City of Burlingame

*Environmental Scoping & Design Review Study for Development
of a New 290-Unit Multiple Family Residential Project*

Item No. 9
**Environmental Scoping &
Design Review Study**

Address: 1008-1028 Carolan Avenue & 1007-1025 Rollins Road

A2.1.1
 Dimension Plan - Ground Floor
 5/12/2014

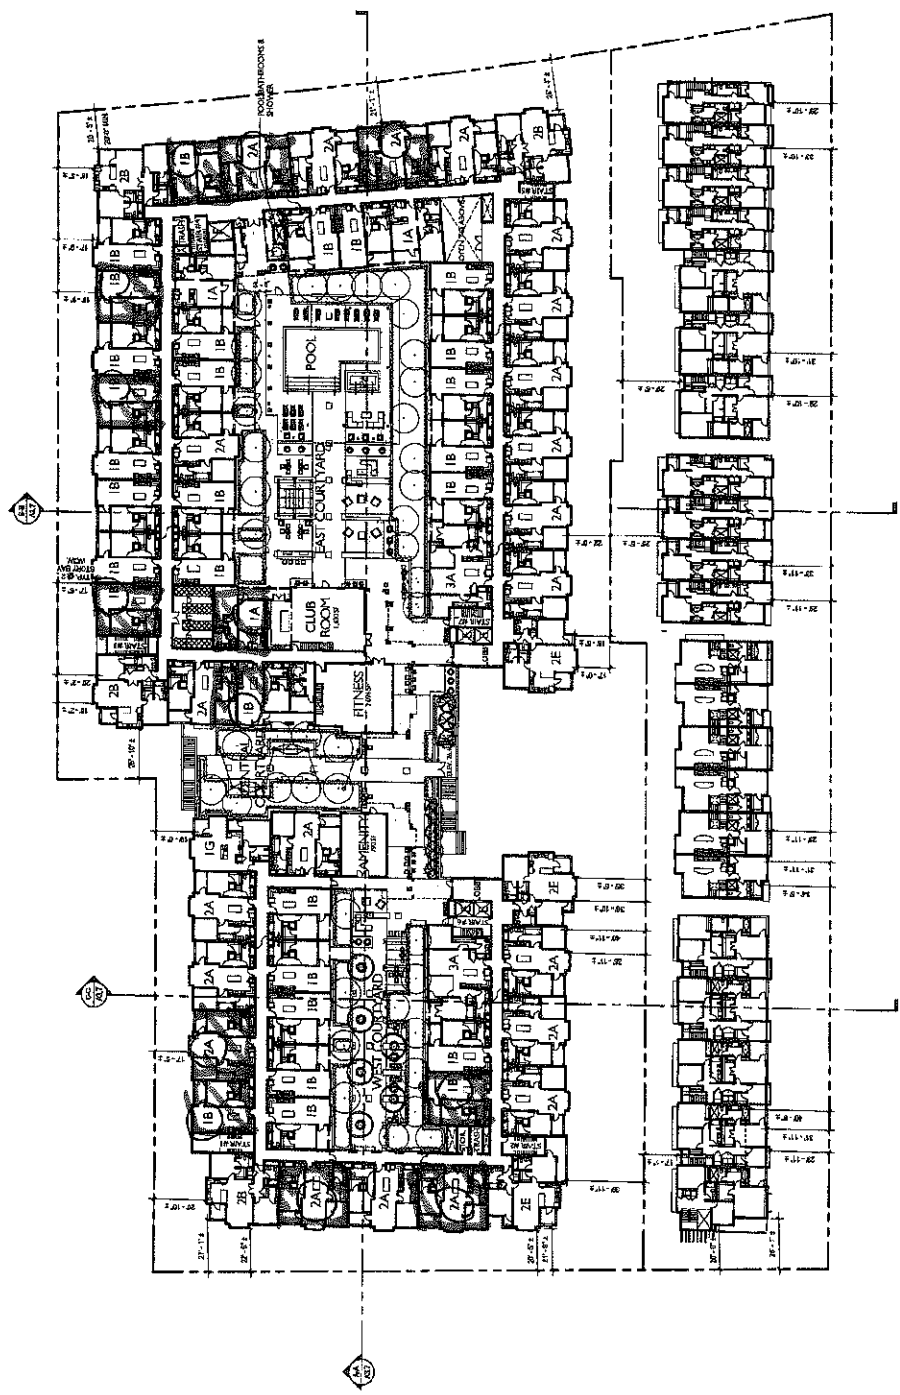
Space #58 is not accessible because the access aisle, as shown, is on the driver's side of the vehicle. On the plans provide a Code-compliant access aisle on the passenger side of the vehicle.
